Huawei Digital Power Technologies Co., Ltd.

Subject: Product Change Notice on Smart Power Sensor

Differences Between DDSU666-H And SmartPS-100A-S0:

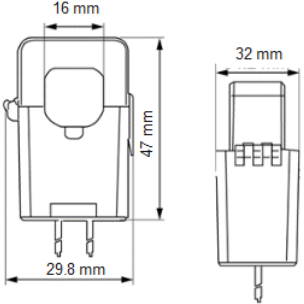
Before	After	
Model	DDSU666-H (Code 20022248)	SmartPS-100A-S0 (Code 20022248-002)	
		DDSU666-H (Chint)	YDS70-C16 (YADA)
Appearance

Label on Box (single product)			
Label on Box (multiple products)			
Dimension (W×H×D)	36 × 100 × 65.5 mm	36 × 100 × 65.5 mm	36 × 101 × 66 mm
Baud rate	4800/9600 (Default 9600bps)	4800/9600/19200/115200 (Default 9600bps)	
Data refresh period	≤0.35s	Power & Power Factor: ≤75ms Other data: ≤200ms	
Dimension of CT			
Pallet dimensions (L×W×H)	1200 × 800 × 1391 mm	1200 × 800 × 1134 mm	1200 × 800 × 1028 mm
Products/Pallet	144	288	288

Differences between DTSU666-H 250A/50mA And SmartPS-250A-T0:

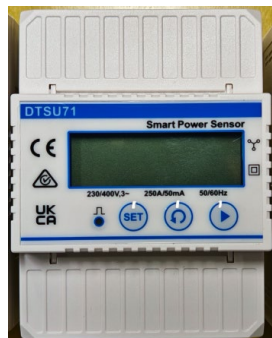
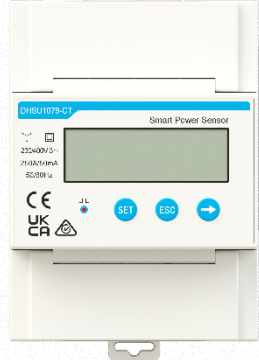
BEFORE	AFTER	
Model*	DTSU666-H 250A/50mA (Code 20022249-001)	SmartPS-250A-T0 (Code 20022249-003)	
		DTSU666-H 250A/50mA (Chint)	YDS60-C24 (YADA)
Appearance	 		
Label on Box (single product)

Label on Box (multiple products)			
Dimension (W×H×D)	72 x 100 x 65.5 mm	72 x 100 x 65.5 mm	72 × 101 × 66 mm
Baud rate	4800/9600 (Default 9600bps)	4800/9600/19200/115200 (Default 9600bps)	
Data refresh period	≤0.35s	Power & Power Factor: ≤75ms Other data: ≤200ms	
Dimension of CT			
Pallet dimensions (L×W×H)	1200 × 800 × 1391 mm	1200 × 800 × 1130 mm	1200 × 800 × 1140 mm
Products/Pallet	144	192	192
